# 資料4-5および4-6の問題点

国立天文台

# 資料4-5の問題点

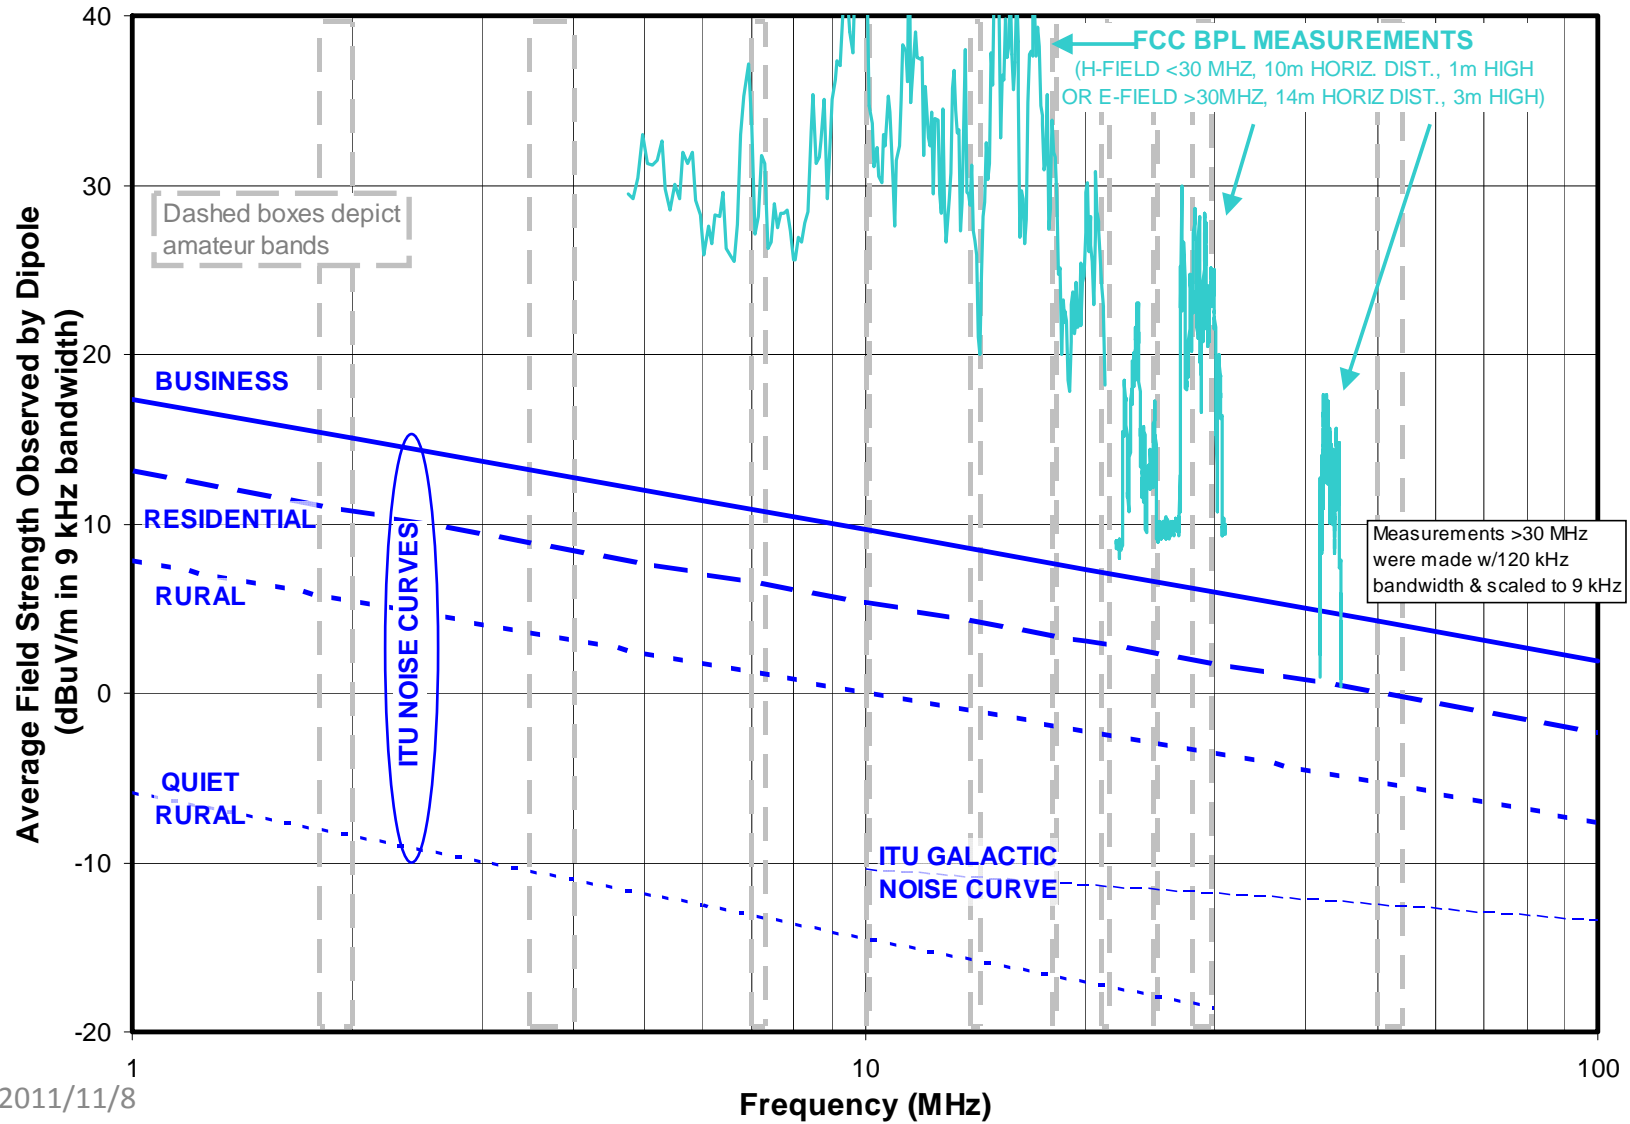
- 資料4-5は、PLC製造業者の団体であるPLC-Jが作成し、米国FCC part15.209に規定する電界強度 (48.6 dB $\mu$ V/m at 10m)を要求
- 一方、PLC-Jは、資料3-2において、無線の受信点における共存条件(電界強度制限値)として28/18 dB $\mu$ V/m at 10mとしている。
- 従って、資料4-5でPLC-Jは、PLCは無線業務と共存できないことを示している。
